**MINUTES
TOWN OF AMHERST
DESIGN ADVISORY BOARD MEETING
January 23, 2025
6:00 PM**

- 1.1. DESIGN REVIEW, SP-1984-27 L; UNIVERSITY CENTER - PROPOSED COFFEE SHOP
Property Located at 4350 Maple Road
Benderson Development, Petitioner

TOWN OF AMHERST
DESIGN ADVISORY BOARD
DESIGN REVIEW FINDINGS
SP 1984-27_L

EXTERIOR
ELEVATIONS

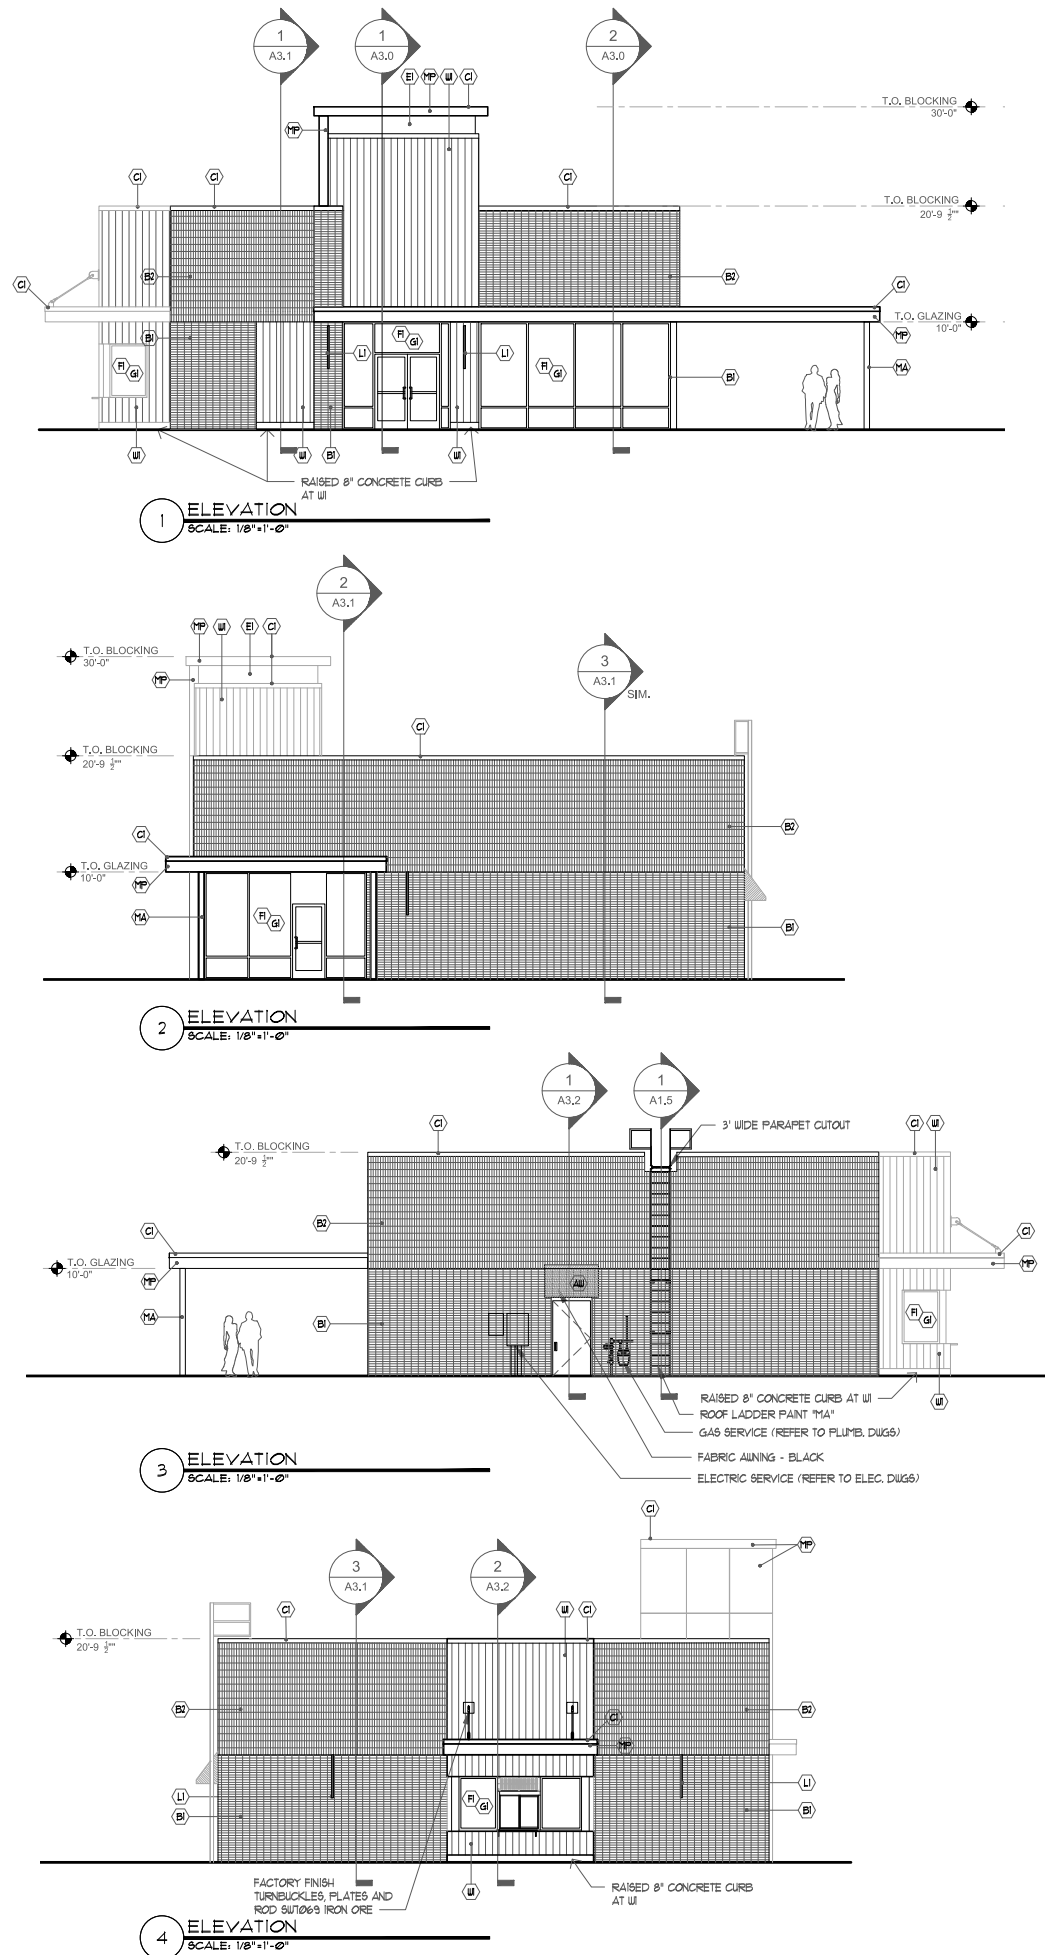
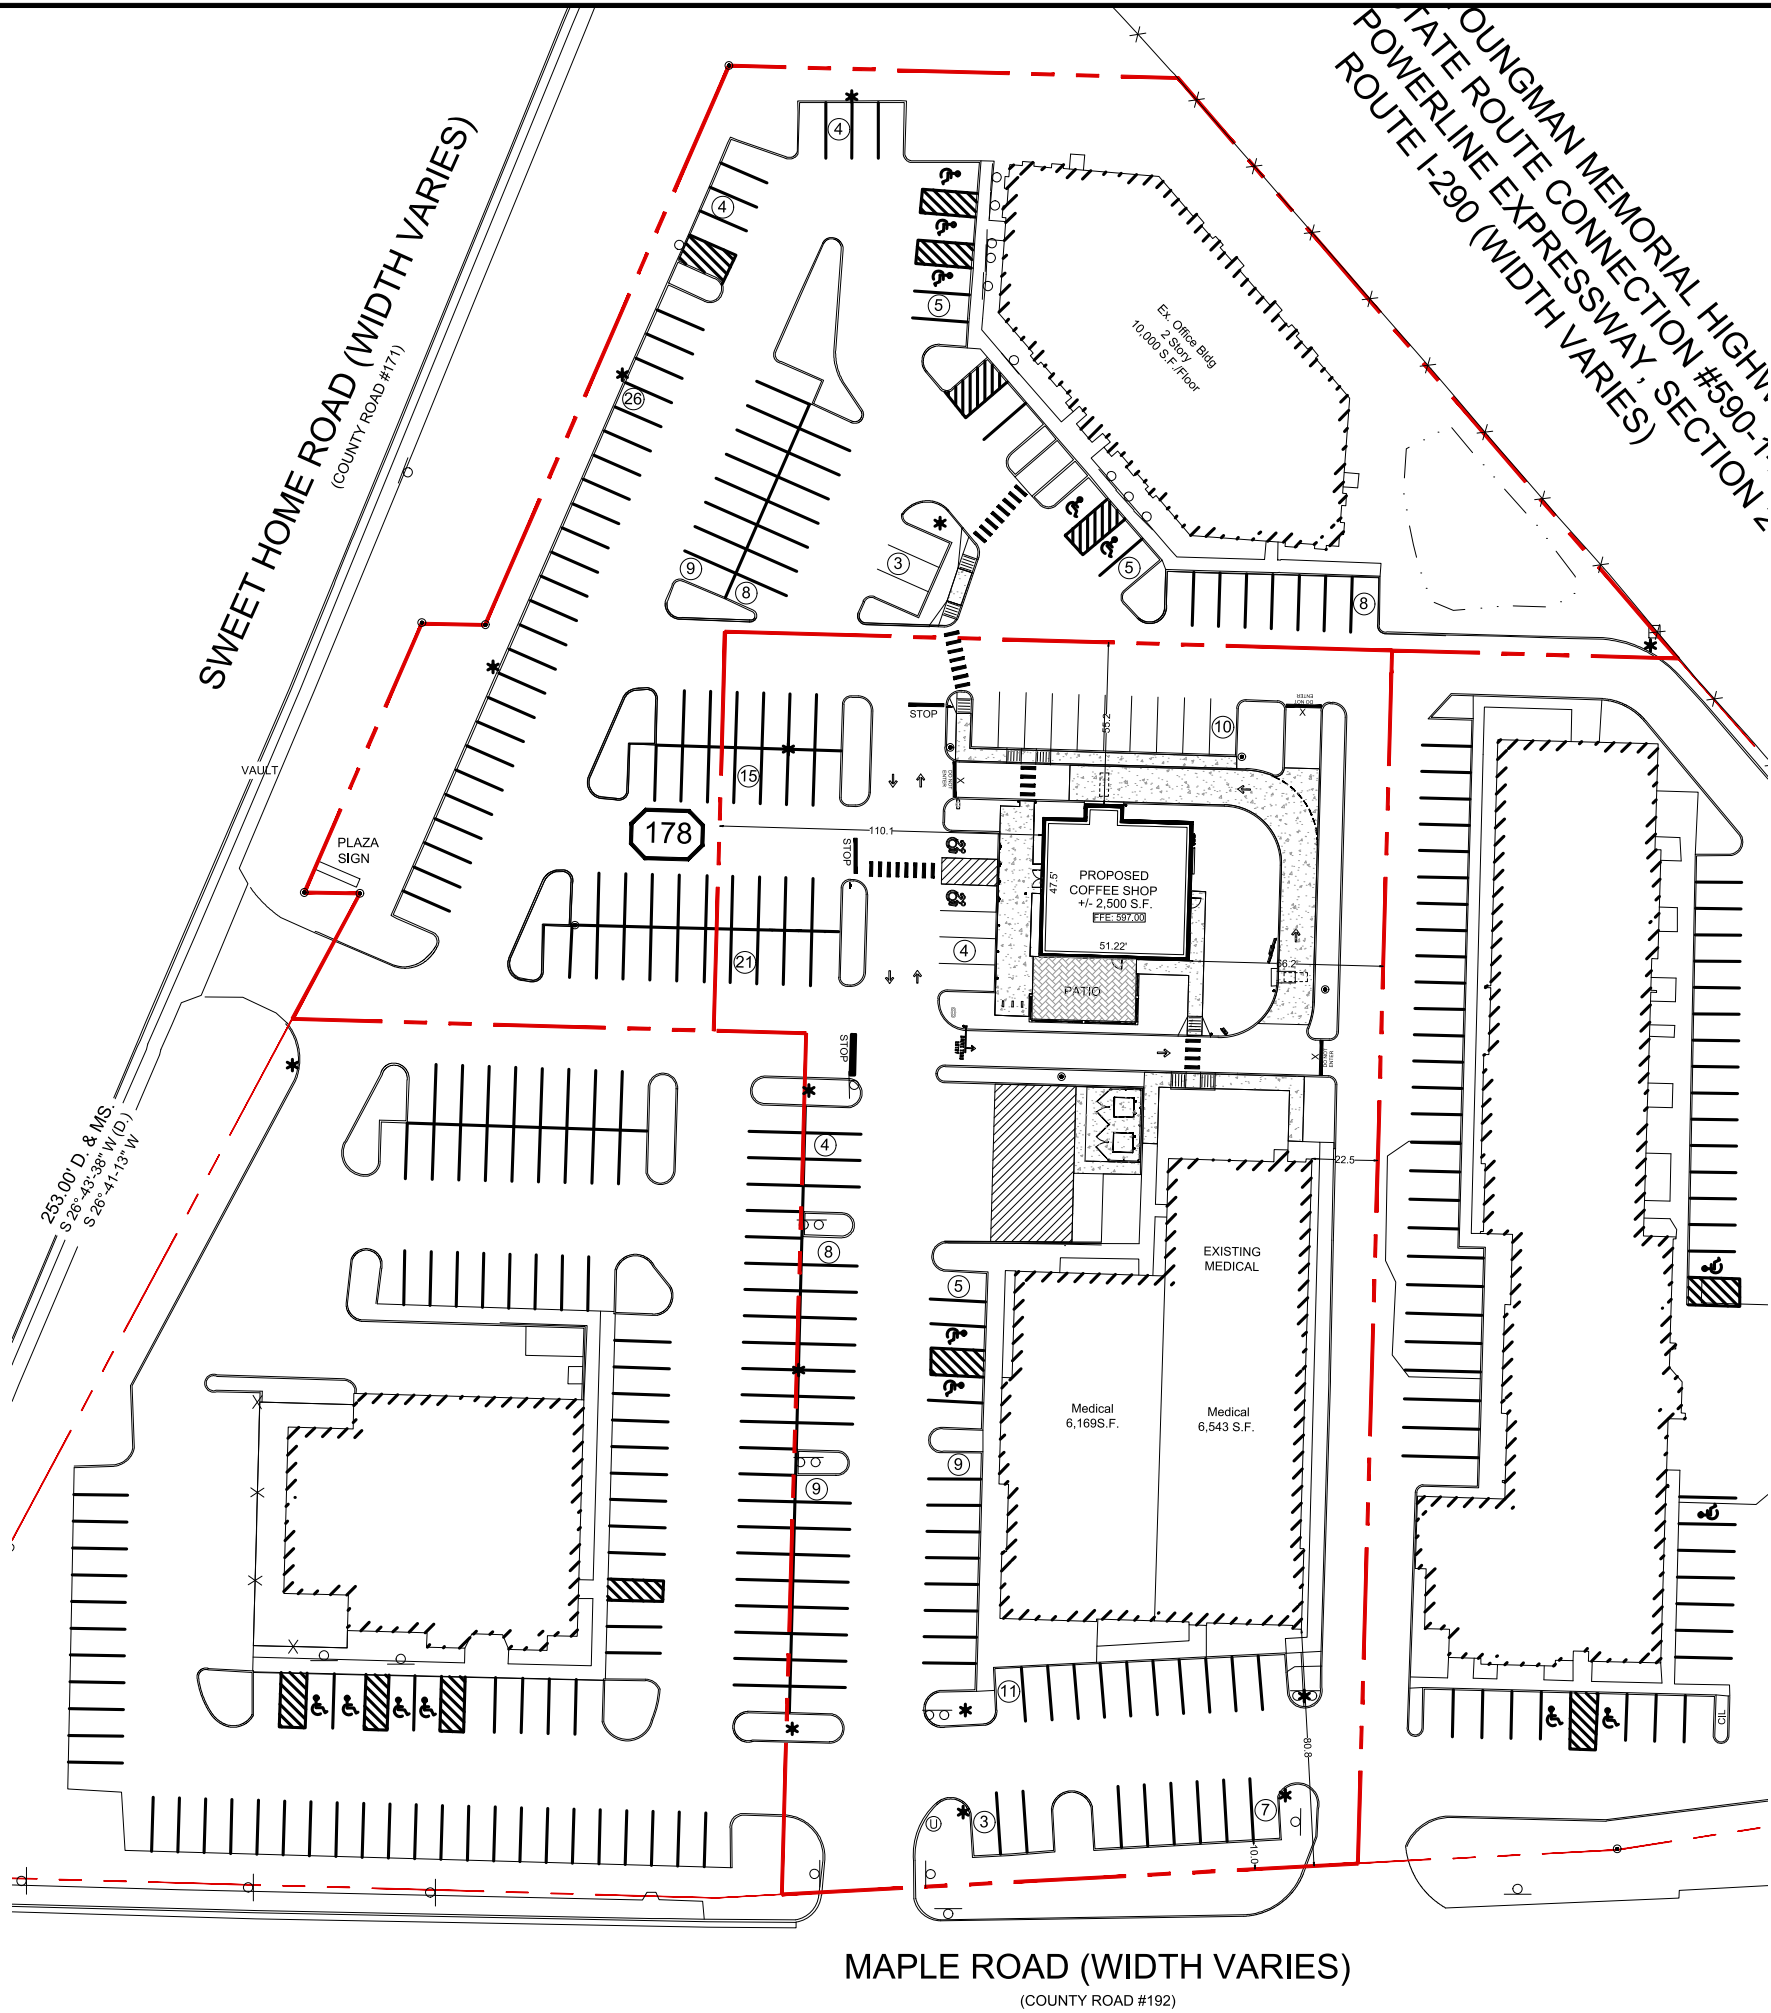
Ms. Conhiser-Uy cited B-1a's guideline of a base, middle, and cap that was not evident in the current design. The rest of the Board agreed although Ms. Colucci noted the dark canopy added a clean line. Ms. Conhiser-Uy stated a water table, or similar, would distinguish the base like a lower mullion. More generally, the base should be made to be continuous. Mr. Rust considered a recessed band, dark brick, or other dark materials to show a water table reveal or shadow line.

Mr. Talty inquired about the siding used on the tower. Mr. Rust explained that two sides had wood while the others had metal to match the cornices. The back was metal because of the adjacent drainage system. The Board recommended three sides be wood to make it continuous but the back could stay metal to accommodate the drainage system.

Ms. Conhiser-Uy asked about the colored stripe on the tower as EIFS is discouraged for durability concerns. Mr. Rust noted that although they could bring the metal down from the cornice, the EIFS line adds color and will be maintained. Mr. Baglioli asserted the petitioner has a long history of properly maintaining their properties including treating wood components every three years.

1. That the site plan and elevation plans be reconciled for the size and extent of the patio (consistent with Guideline A-2.a).
2. That access to the bike rack avoid landscaped areas (consistent with Guideline A-3b).
3. That the inclusion of an artistic bike rack or other public art be included in plans (consistent with Design Guidelines A-4.a).
4. That a visual water table (with recess, color or similar) be added to distinguish the base (consistent with Design Guidelines B-1.a).
5. That three sides of the tower be wood and the back be metal to accommodate drainage system (consistent with Design Guidelines B-7.c).

Overall
Site Plan

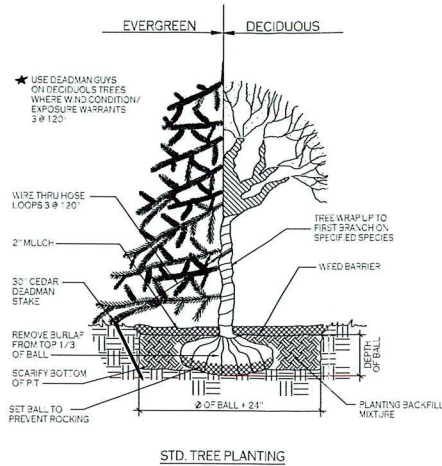
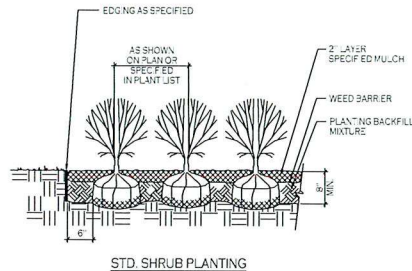
Mr. Talty suggested widening the greenspace to the building's north but Mr. Baglioli explained that would impede traffic flow.

Anne Dafchik, Town Architect, noted the inconsistent size of the covered patio between drawings. Mr. Baglioli clarified it was likely a drafting error that would be rectified during the Town staff's review.
